## IEEE P802.15 Wireless Personal Area Networks

Project	IEEE P802.15 Working Group for Wireless Personal Area Networks (WPANs)	
Title	<b>TG3 Rolling Meadows Ad-Hoc Working Document</b>	
Date Submitted	[1 November, 2001]	
Source	[James P. K. Gilb] [Mobilian] [12707 High Bluff Dr., Suite 335, San Diego, CA 92130]	Voice: [858-436-2201] Fax: [858-436-2301] E-mail: [gilb@ieee.org ]
Re:	[]	
Abstract	[This document is contains the issues and resolutions developed by the TG3 subcommittee at the Rolling Meadows ad-hoc meeting. It also serves to document the addtions made to the draft standard D07 to produce D08.]	
Purpose	[To provide a record of the resolutions of TG3 and the changes to the draft standard D07 to make D08.]	
Notice	This document has been prepared to assist the IEEE P802.15. It is offered as a basis for discussion and is not binding on the contributing individual(s) or organization(s). The material in this document is subject to change in form and content after further study. The contributor(s) reserve(s) the right to add, amend or withdraw material contained herein.

Figure 3—CTA assignment sequence for pseudo-static GTSs

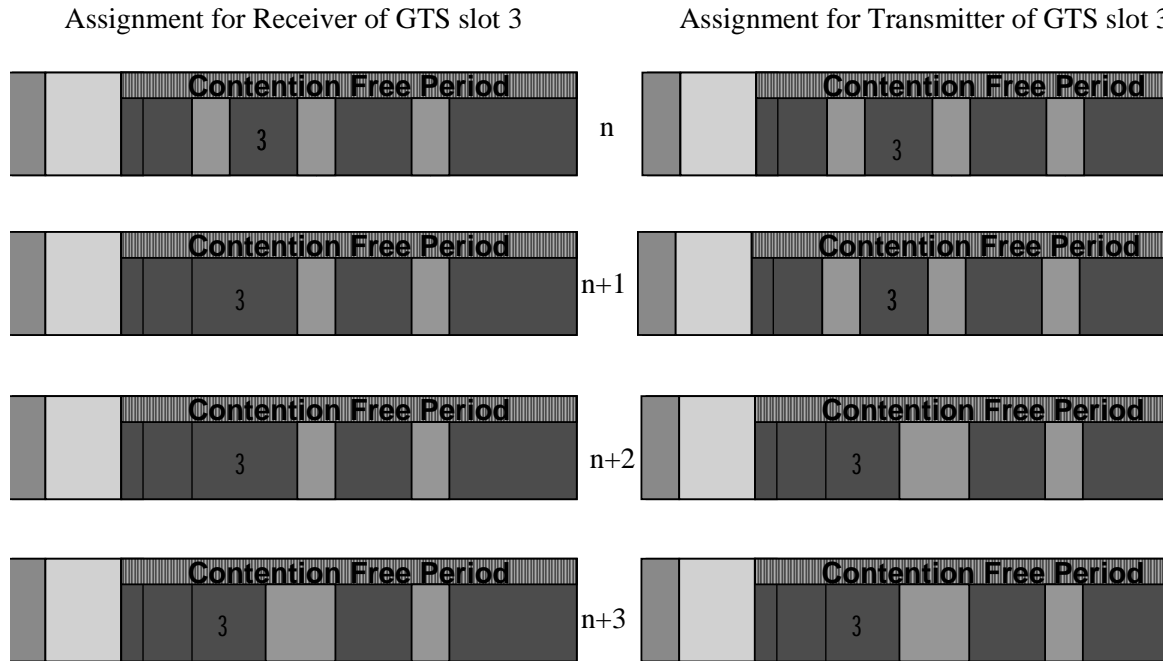
### 7.2.5 New Clause 8.3.3.1.3 Pseudo Static Guaranteed Time Slots

Pseudo static GTSs can be moved by the PNC, but the PNC must notify the affected DEVs by sending them acknowledged Channel Time Grant frames with the new CTA. As with dynamic GTSs, the PNC can rearrange pseudo static GTSs so that the GTS assignments can be optimized, but it must use the Channel Time Grant and coordinate the channel time grants with the CTAs in the beacon.

Before a pseudo static GTS is moved, the PNC shall ensure that the new position is unoccupied by another GTS. Then, the PNC sends a directed channel time grant to the receiving DEV so that the receiving DEV is listening to both the old GTS position and the new position. This channel time grant contains both the old and the new CTA. If the old and the new position overlap, the CTA can be one larger CTA.

1 Next the PNC sends a channel time grant to the transmitting DEV that contains only the new CTA. By mov-  
2 ing the receiver first, the PNC ensures that no frames are lost if Channel time requests are corrupted.

3  
4 Lastly, the PNC sends a channel time grant to the receiving DEV which only contains the new CTA.

5  
6 DEVs can request a change in a pseudo-static Slot channel time using the Channel Time Request command.

23  
24 Pseudo-static GTSs may be moved by the PNC, but the PNC needs to notify the affected DEVs by sending channel time  
25 grant frames, 7.5.5.2, with the new CTA. As with dynamic GTSs, the PNC may rearrange pseudo static GTSs so that the  
26 GTS assignments will be optimized, but it must use the channel time grant command and coordinate the channel time  
27 grants with the CTAs in the beacon.

28  
29 Before a pseudo static GTS is moved, the PNC shall ensure that the new position is unoccupied by another GTS. Then,  
30 the PNC shall send a directed channel time grant to the receiving DEV so that the receiving DEV is listening to both the  
31 old GTS position and the new position. The channel time grant shall be acknowledged with an Imm-ACK by the DEV if  
32 it is received correctly. If the PNC does not receive an Imm-ACK, it may re-send the channel time grant command, but it  
33 shall not continue with the process until the acknowledgement is received. The channel time grant sent by the PNC to  
34 the receiving DEV contains both the old and the new CTA. If the old and the new position overlap, the CTA may be one  
35 larger CTA.

36  
37 The PNC shall then send a channel time grant to the transmitting DEV that contains only the new CTA. The transmitting  
38 DEV shall acknowledge with an Imm-ACK if it is received correctly. If the PNC does not receive the Imm-ACK, it may  
39 re-send the channel time grant command, but it shall not move the pseudo-static GTS until the acknowledgement is  
40 received. By moving the receiver first, the PNC ensures that no frames are lost if channel time requests are corrupted.

41  
42 Finally, the PNC shall send a channel time grant to the receiving DEV which only contains the new CTA. The receiving  
43 DEV shall acknowledge this command with an Imm-ACK if it is received correctly. If the PNC does not correctly  
44 receive the acknowledgement, it may re-send the channel time grant command. However, the PNC may re-allocate the  
45 original pseudo-static GTS even if it does not receive the acknowledgement to the command.

46  
47 Throughout the process, the PNC will ensure that the beacon contains the current CTAs for the pseudo-static GTS that it  
48 is moving.

49  
50 DEVs may request a change in a pseudo-static GTS channel time using the channel time request command.

A graphical illustration of the procedure for moving a pseudo-static GTS is illustrated in Figure 3
